# Access Compliance Report

## Public Rights-of-Way

### (Curb Ramps)

Intersection ID: 8925	Main Street: E_W_T_HARRIS_BV	Cross Street: THE_PLAZA	Location: SE
ADA ID: 92FCDFDC2C5C	Ramp Type: Para	Initial Pass/Fail: Pass	Overall Compliance: No
		Severity Score: 7.75

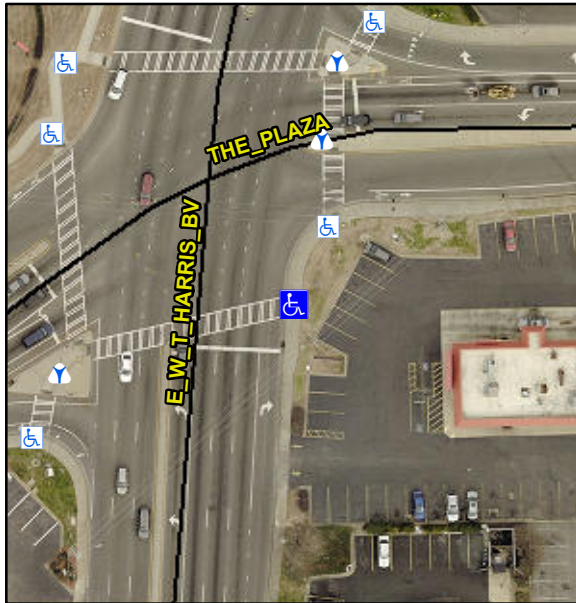
**R304.5.3, R304.2.2-Perp, R304.3.2-  
Para, R305.2, R302.7, R302.7.2**

Compliance	Description	Data	Compliance	Description	Data
N/A	Ramp Length LT (in)	74.0	N/A	Ramp Length RT (in)	70.0
Yes	Ramp Width LT (in)	82.5	Yes	Ramp Width RT (in)	82.5
Yes	Ramp Slope LT (%)	6.8	Yes	Ramp Slope RT (%)	6.8
No	Ramp XSlope LT (%)	2.1	No	Ramp XSlope RT (%)	2.5
Yes	Landing Length (in)	82.5	Yes	DWS Provided?	Yes
Yes	Landing Width (in)	48.0	Yes	DWS Contrast?	Yes
No	Landing Slope (%)	2.6	Yes	DWS Length (in)	24.0
Yes	Landing X Slope (%)	0.9	Yes	DWS Full Width?	Yes
N/A	Landing Curb? (Y/N)	No	No	DWS Offset (in)	2.5
N/A	Shared Landing?	No			
No	Gutter Ponding?	Yes	Yes	Gutter Slope (%)	2.1
No	Gutter Lip Ht (in)	0.5	Yes	Gutter X Slope (%)	0.6
N/A	Painted X Walk1?	Yes	N/A	Painted X Walk2?	N/A
	X Walk 1 Direction	To SW		X Walk 2 Direction	N/A
N/A	X Walk 1 Width (in)	114.0	N/A	X Walk 2 Width (in)	N/A
	X Walk 1 Slope (%)	3.4		X Walk 2 Slope (%)	N/A
	X Walk 1 X Slope (%)	0.7		X Walk 2 X Slope (%)	N/A
Yes	Ramp inside XWalk1?	Yes	N/A	Ramp inside XWalk2?	N/A

**Remove & Replace Entire Ramp.  
Grind Gutter Lip.**
